**ADDENDUM**

SUBJECT: **ADDENDUM TO ITEM W9d, CDP NO. 5-15-0060 FOR THE  
COMMISSION MEETING OF WEDNESDAY, OCTOBER 7, 2015.**

**Application No.:** 5-15-0060

**STAFF REPORT: REGULAR CALENDAR**

## Proposed Dock

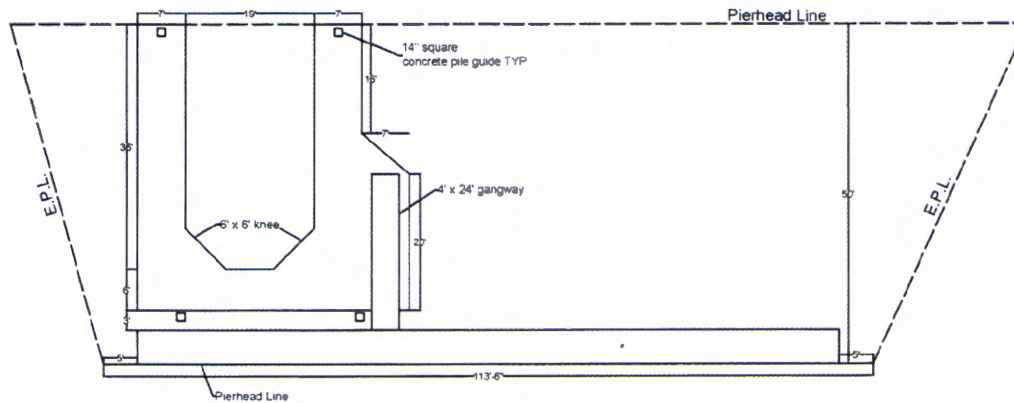
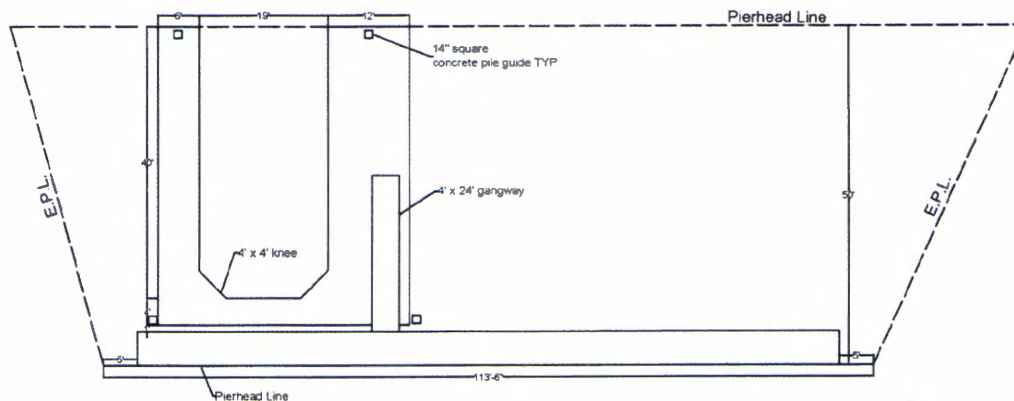
The agents' letter discusses several reasons why they are in disagreement with special condition No. 1. In her letter she states that the Harbor Design Criteria Guidelines and Standards Table 1, where Commission staff found that the minimum required width for the proposed project would be 4' wide, only demonstrates the minimum finger widths in relation to the length of the finger. She continues to state that the final decision is made by the Harbor Resources Division, as they take into account safety standards, appurtenances or accessories, such as, water supply, electrical supply, boating related storage, etc. The agent also states the proposed dock should be allowed

since the proposed dock has the least amount of water coverage compared to nine larger lot homes at the two ends of the horse shoe shaped Linda Isle that have docks averaging approximately 1,112 square feet in size. The agent states that the applicant originally wanted to install a long "I" shaped dock similar to adjacent docks, but due to the presence of eelgrass and potential impacts to eelgrass this was not chosen. Additionally, the agent states that they had initially designed the project so that a pier platform could be installed as part of the dock system, where boating related accessories, such as mast storage, a kayak rack and storage boxes would be placed. However, due to the presence of eelgrass near the boat dock system and impacts upon it from installation of the pier platform, the pier platform component was not included as part of the project and instead the fingers were designed to be wider to accommodate the boating related accessories.

California Coastal Commission Staff's **Special Condition No. 1** requesting revised project plans to minimize the finger width from 6' and 12' to 4' while maintaining the minimum headwalk width of 6' and 16 square feet for two knee structure is based on an interpretation of the City of Newport Beach Harbor Resources Division Harbor Design

Commission staff has imposed Special Condition No. 1 in order to minimize the overall water coverage of the proposed dock system in accordance with the City of Newport Beach Harbor Resource's Harbor Design Criteria Guidelines and Standards to protect marine resources. Water coverage of coastal waters is a significant concern because it reduces the amount of light and decreases the biological productivity of coastal waters and impedes wildlife foraging activities. Reducing the proposed dock system to the minimal amount necessary as dictated by the Harbor Design Criteria Guidelines and Standards results in less water coverage while still being able to provide for a usable dock system.

# Existing vs. Proposed

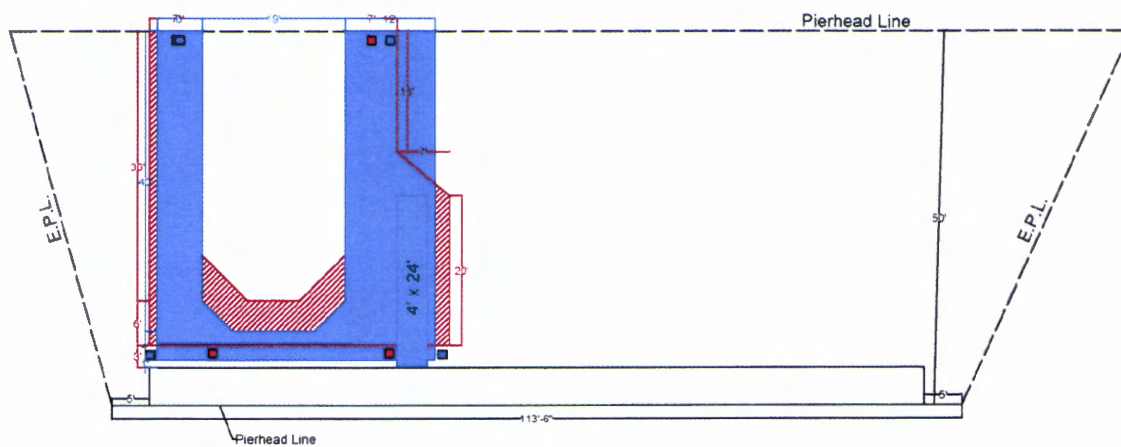
This near like-for-like replacement of the floating dock system consists of removing an 896 square foot floating dock and replacing it with an 884 square foot floating dock. This is a **DECREASE** of 12 square feet. The (4) 14" square pile will be replaced with the same. As will the 24 x 4 gangway. Please see **Exhibit No. 1** and **Exhibit No. 2**.

Figure 2. Existing: Dive transects, eelgrass, quadrats and proposed addition to finger

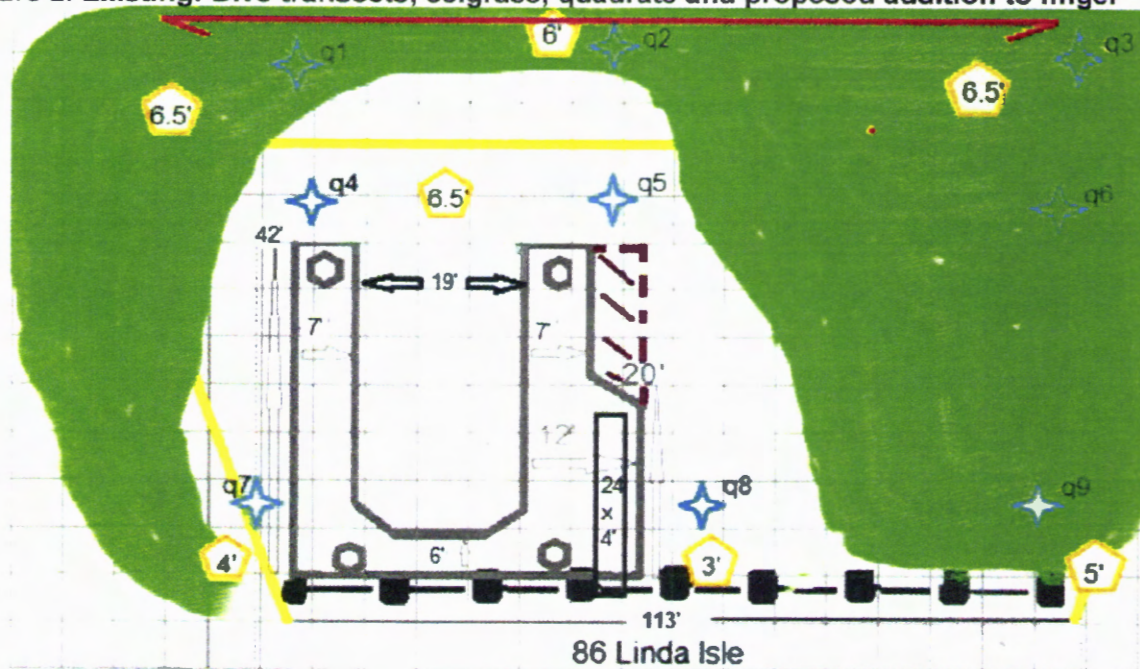
Eelgrass is present within the project area. There is no Caulerpa present. Because the proposed design is near like-for-like, there will not be any impact to eelgrass. We have agreed to a Pre-Construction survey for eelgrass as requested under **Special Condition No. 2**. In addition to a Pre-Construction survey for Caulerpa as requested under **Special Condition No. 3**.

subject site and thus adverse impacts to eelgrass are always a significant possibility. The current eelgrass survey which identifies that no eelgrass is impacted is no longer valid; therefore, a pre-construction eelgrass survey should be conducted. Therefore, the Commission imposes **Special Condition No. 2**, which requires a new eelgrass survey and identifies the procedures necessary to be completed prior to beginning construction, in case the new survey also expires prior to commencement of construction.

Floating Dock 896 sq. ft.

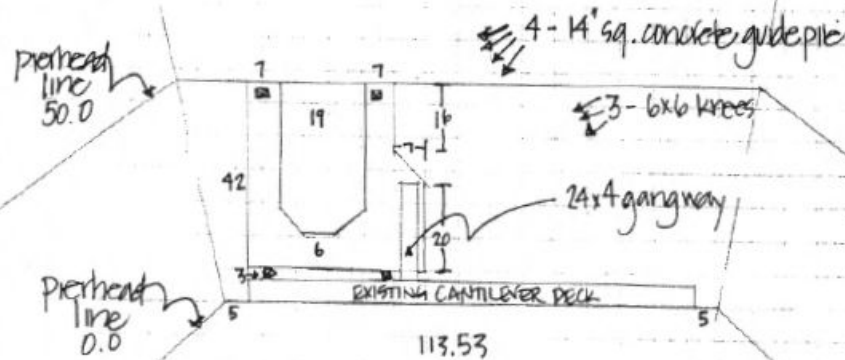
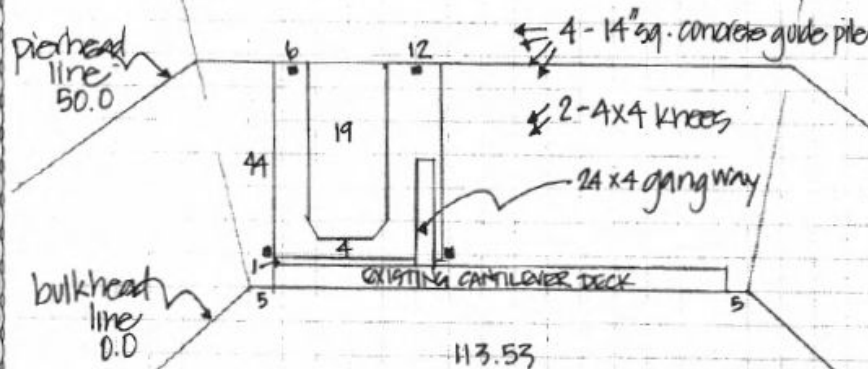
The City of Newport Beach Harbor Resources Division has established Harbor Design Criteria Guidelines and Standards for residential dock projects. The minimum required finger widths for the dock based on the lengths of the applicant's proposed berth is 4'. The applicant is proposing widths of 6' and 12'. The minimum width of the float dock headwalk based on the applicant's proposed dock length can be a minimal width of 4', as the applicant has proposed. In order to accommodate storage boxes originally intended to be placed on a standard 10' x 14' (140 square feet) pier platform that could not be included due to adverse eelgrass impacts, Commission staff has included that area (a maximum of 140 square feet) in the amount of area that could be included in the boat dock system to accommodate boating related storage containers. Even with the additional allotment of square footage for storage boxes, the overall square footage of the revised boat dock system based on the minimum standards of the Harbor Design Criteria Guidelines and Standards would result in less water coverage (584 square feet) than the existing (896 square feet) and proposed (884 square feet) boat dock systems.

In order to minimize adverse impacts to biological resources and to ensure that there will not be negative cumulative impacts to the Newport Harbor ecosystem, the proposed increased water coverage of the new boat dock system must be reduced. Therefore, the Commission imposes **Special Condition No. 1**, which requires the applicant to submit revised project plans to minimize the finger width from 6' and 12' to 4' while maintaining the minimum headwalk width of 6' and 16 square feet for two knee structures and including as an option, an additional maximum 140 square feet for storage boxes. This will result in a dock system varying from a minimum of 444 square feet to 584 square feet.

Revised Dock Float Fingers (Minimum Requirements)
Head Walk: 4' wide x 19' long = 76 square feet
Finger: 4' wide x 44' long = 176 square feet
Finger: 4' wide x 44' long = 176 square feet
Knees: 4' x 4' triangle (2) = 16 square feet
Pier Platform Storage Area: 10' wide x 14' long = 140 square feet
Total: 584 sq. ft.
